1722B – PROPOSAL FOR ENHANCED CONTROL FORMATS

DON PANNELL
10 MAR 2020

Overview

IEEE 1722b – Larger bus_id size – Proposal for CAN

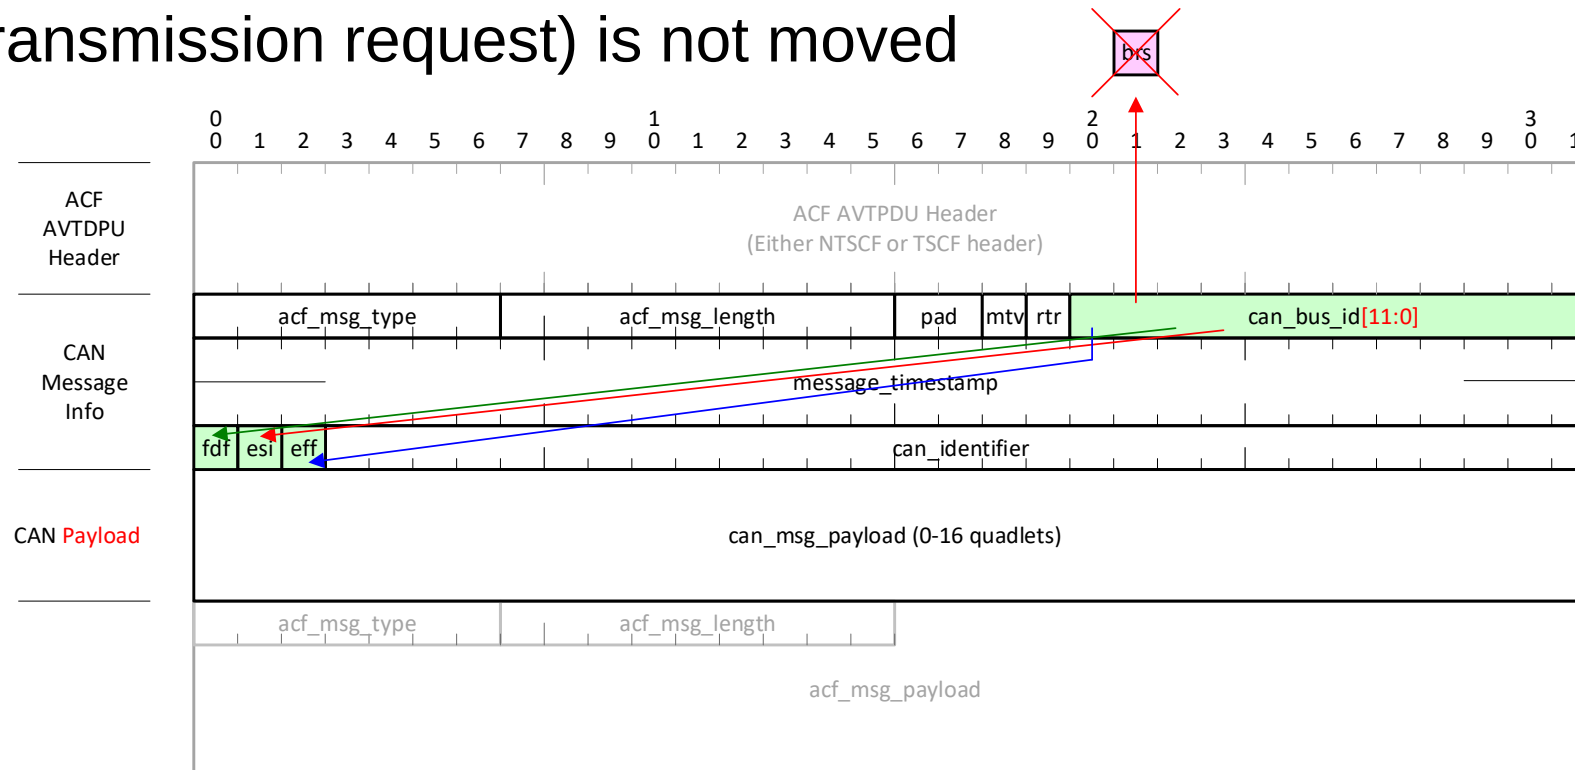
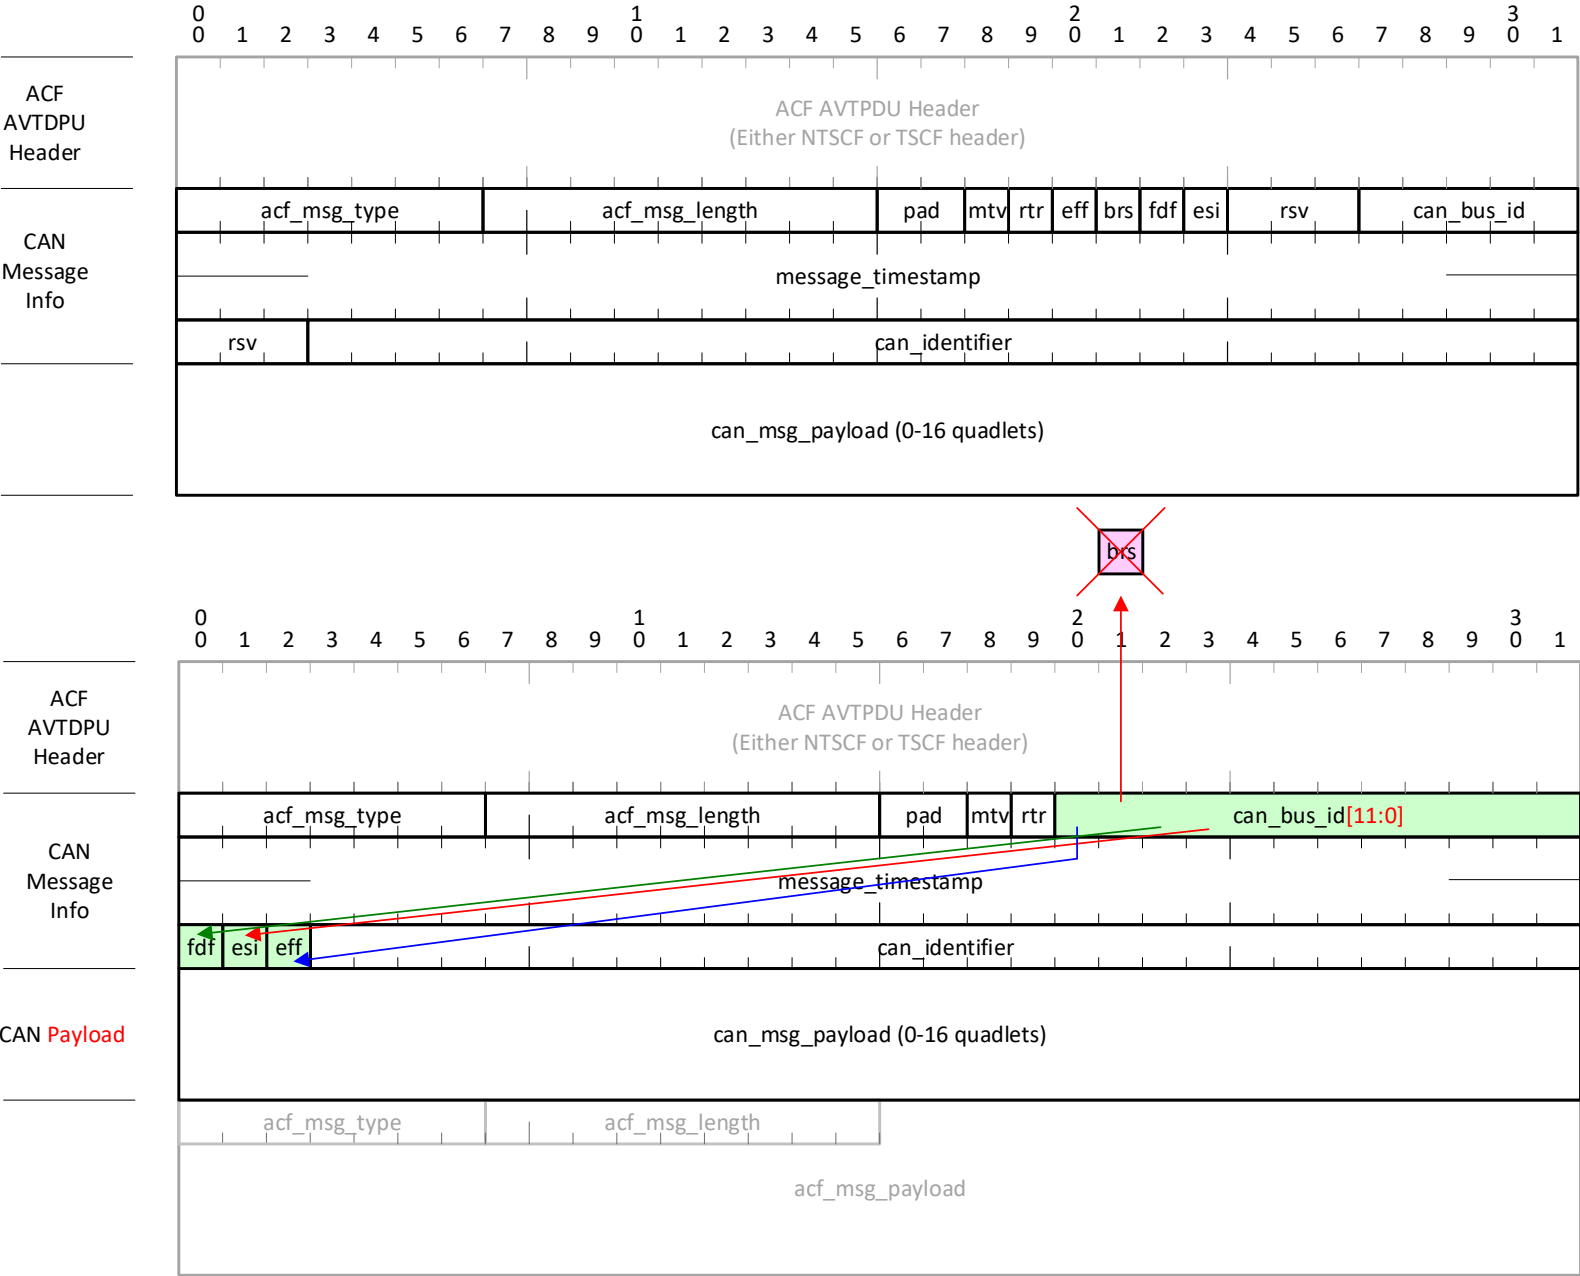
- Move fdf (flexible data rate), esi (error state indicator) & eff (extended frame format) bits to previously reserved bits & remove the brs (bit rate switch) bit as shown
- Extend the can_bus_id to 12 bits (the lower 5 bits are in the same location)
- The CAN format requires the most bits, thus limiting the bus_id to 12 bits
- rtr (remote transmission request) is not moved

IEEE 1722b – Larger bus_id size – Proposal for CAN BRIEF

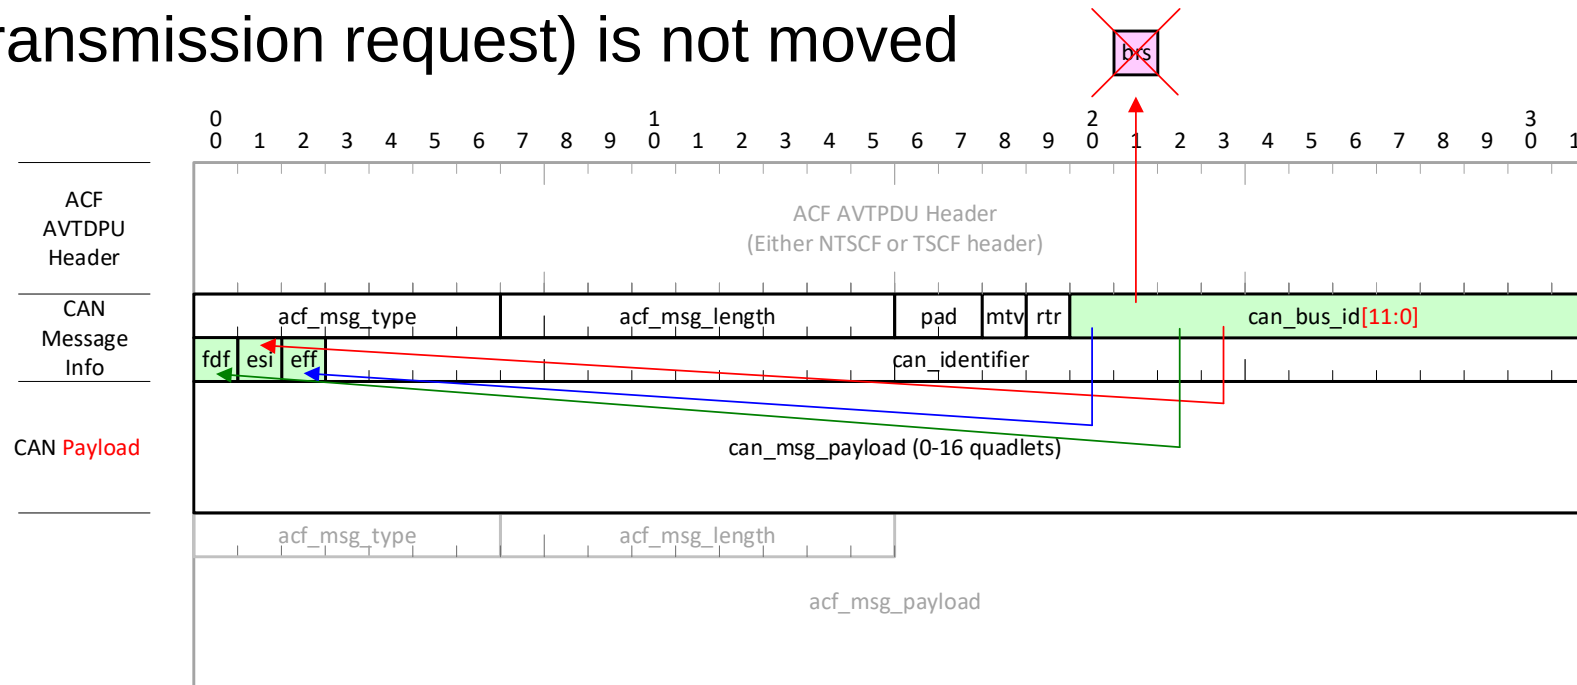
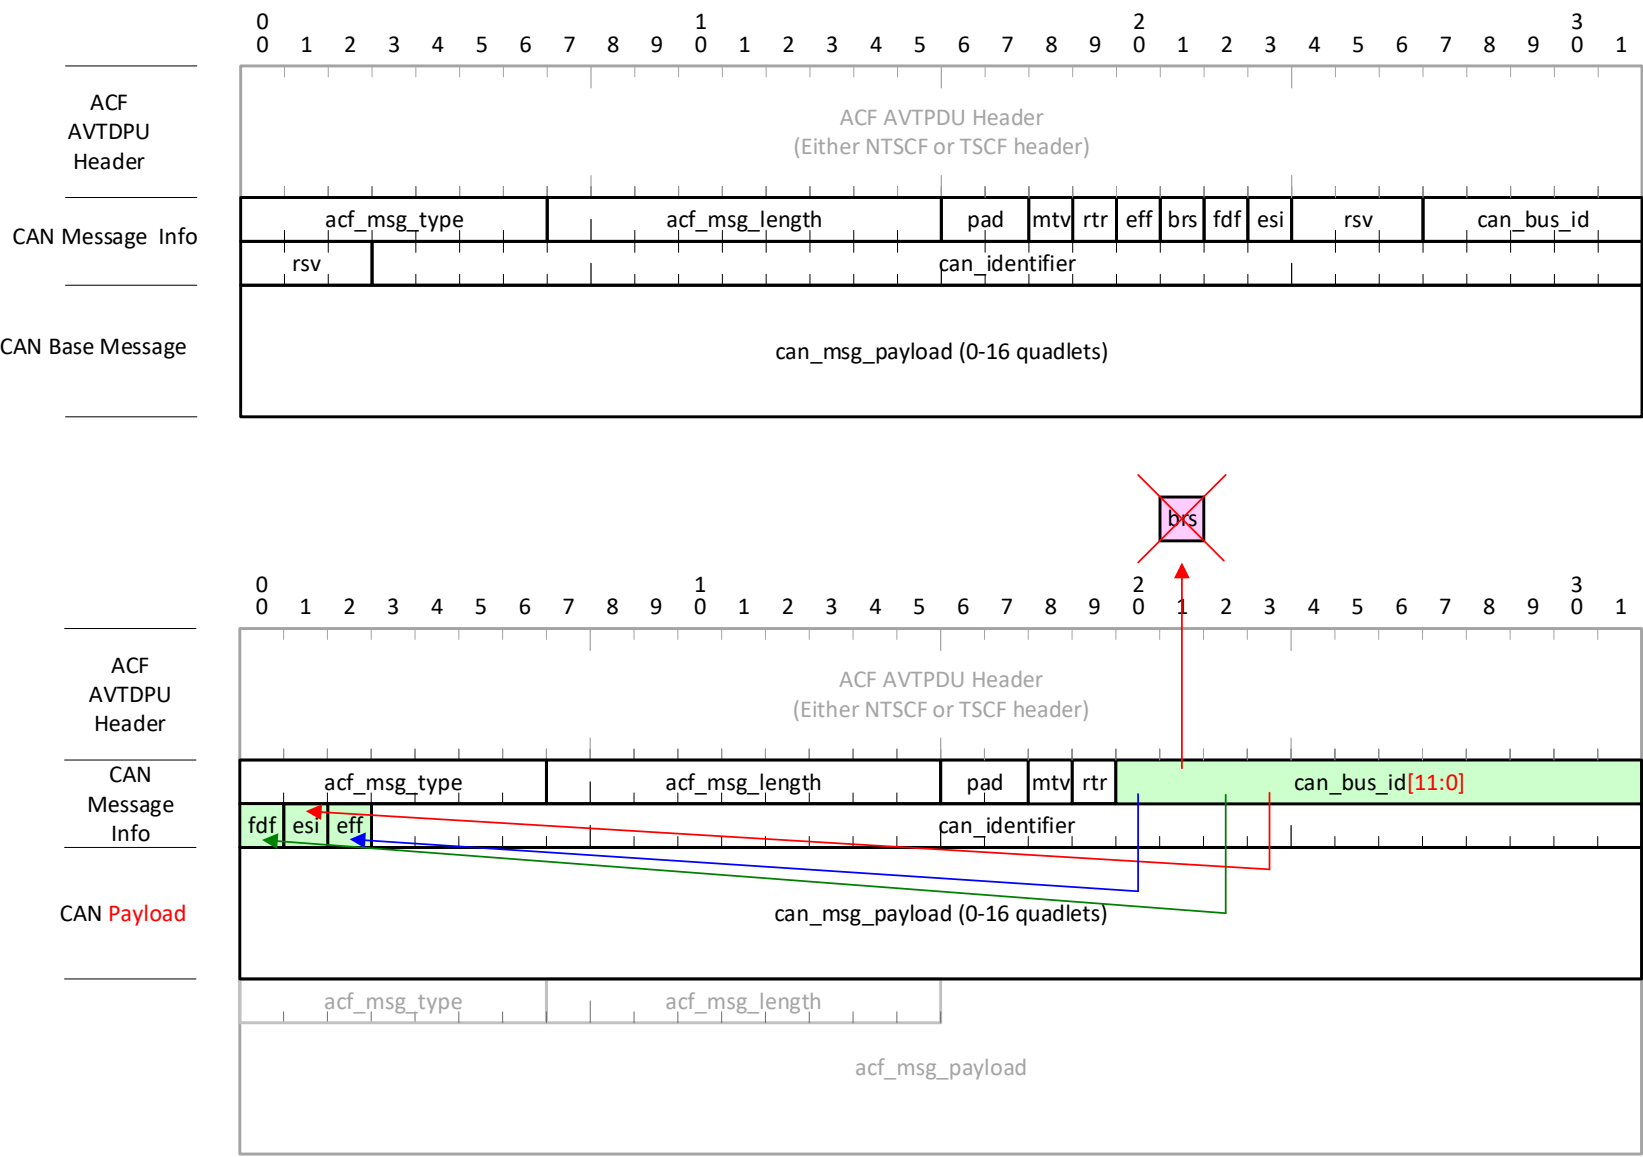
- CAN BRIEF gets the same changes as were done with CAN
- Move fdf (flexible data rate), esi (error state indicator) & eff (extended frame format) bits to previously reserved bits & remove the brs (bit rate switch) bit as shown
- Extend the can_bus_id to 12 bits (the lower 5 bits are in the same location)
- rtr (remote transmission request) is not moved

IEEE 1722b – Larger bus_id size – Proposal for LIN

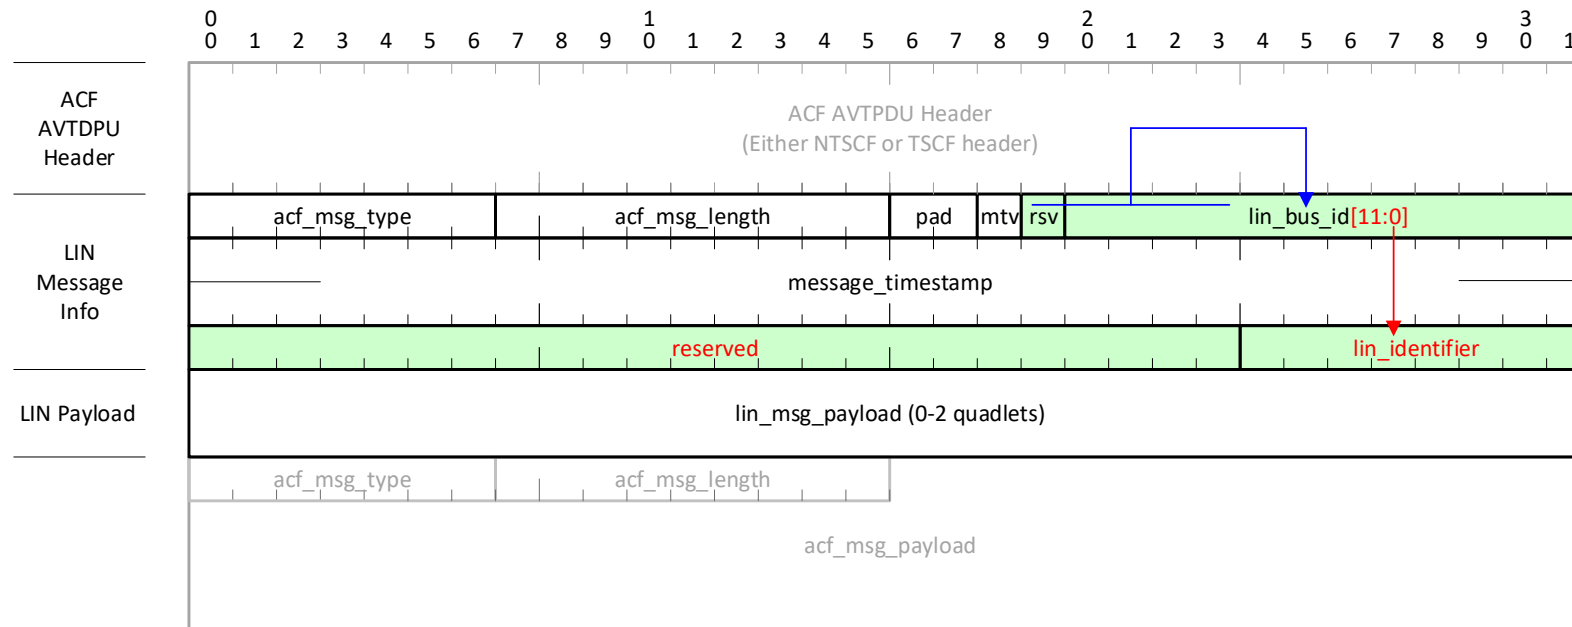
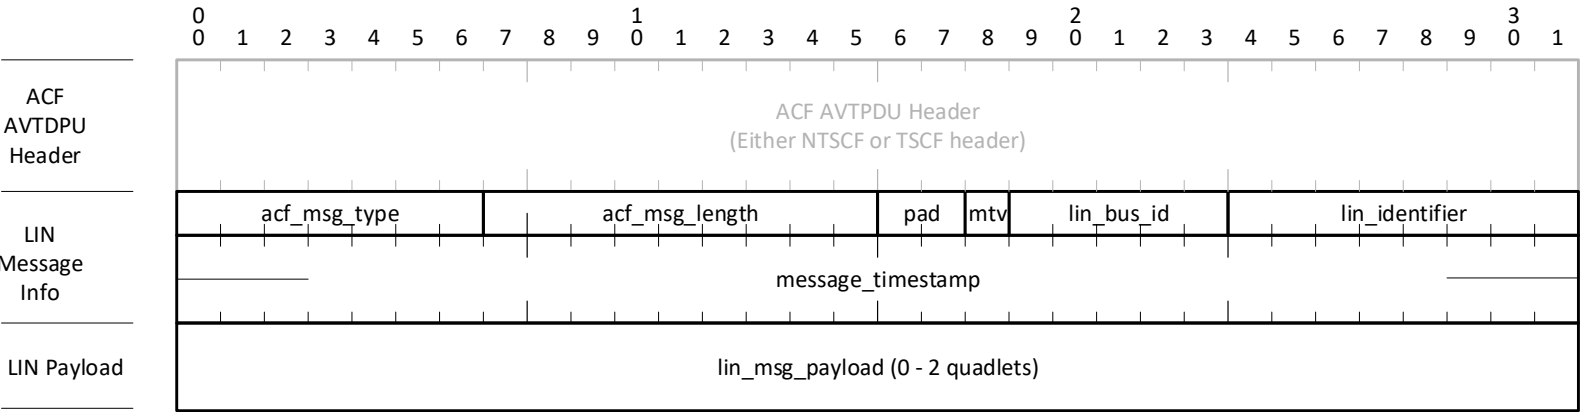
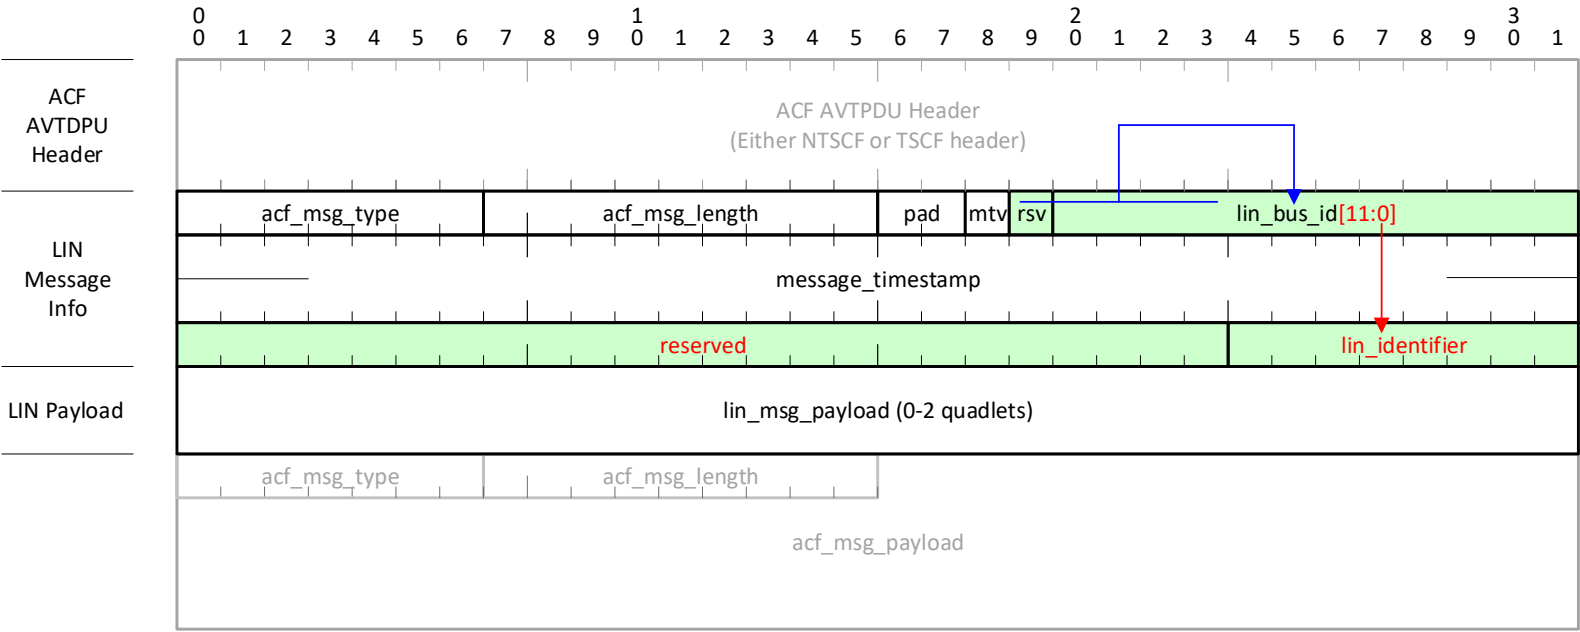
- LIN was fully packed, so a full quadlet needs to be added (added green quadlet)
- The lin_identifier is moved to the new quadlet in the same area as the can_identifier (although its not as large as CAN's)
- The lin_bus_id is shifted right by 8 bits & expanded to 12 bits leaving a rsv bit
